PCN-2014-543

**Assembly Site Transfer from StatsChipPac Kuala Lumpur, Malaysia (SCM)
to ANST Wuxi CHINA for the CS4265-CNZ(R) component**

**Process/Product Change Notification
(Reference Advance PCN-2014-523)**

Date: June 2014

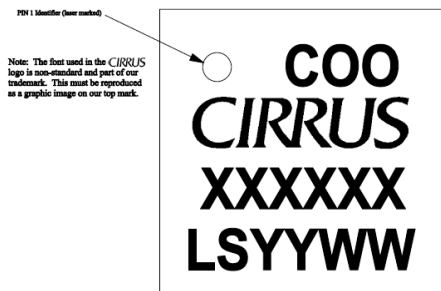
Mark change:

- Assembly vendor = None (not shown on mark)
- COO = changing From: **MYS** → TO: **CHN**

With the Assembly Site Transfer to ANST Wuxi CHINA, the material will receive the appropriate designation for the Assembly Site Country Of Origin.
